## **ROCKY MOUNTAIN ARSENAL**

CONTAMINATION ASSESSMENT REPORT SITE 36-12: PITS/TRENCHES (Version 3.2)

January 1988 Contract Number DAAK11-84-D0016 Task Number 1 (Section 36)

APPENDIX 36-12-C COMMENTS AND RESPONSES

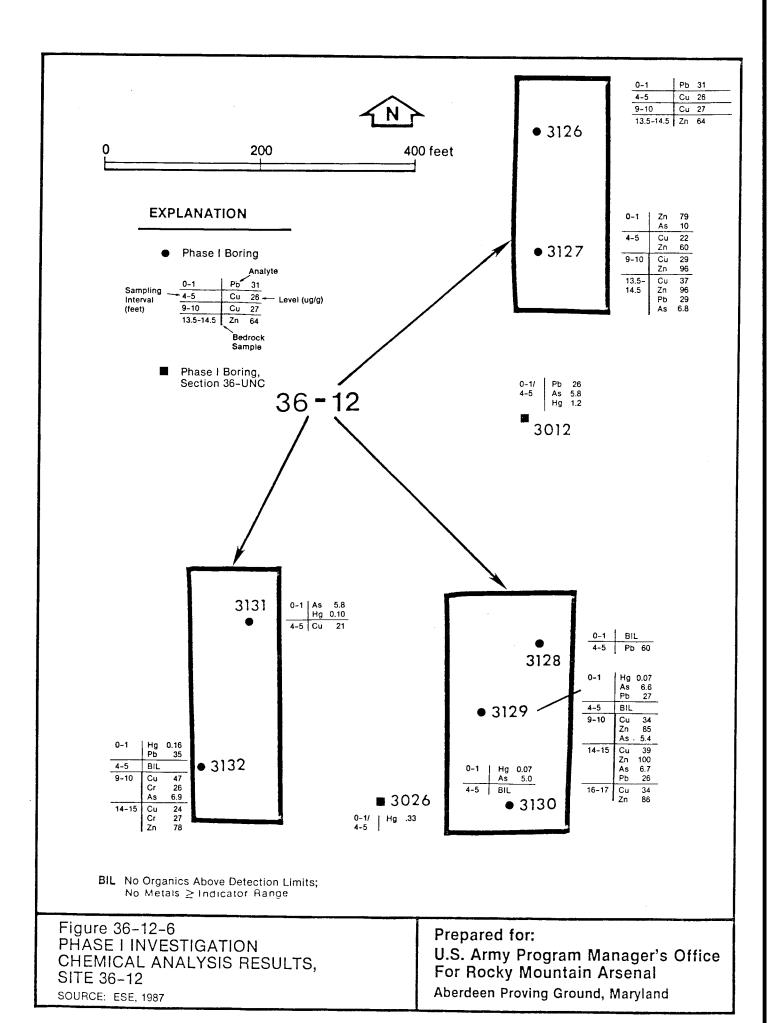
Comment\_2:

Response: The figures only showed values above the lower indicator

level at that time. These results have been added to the

figure.
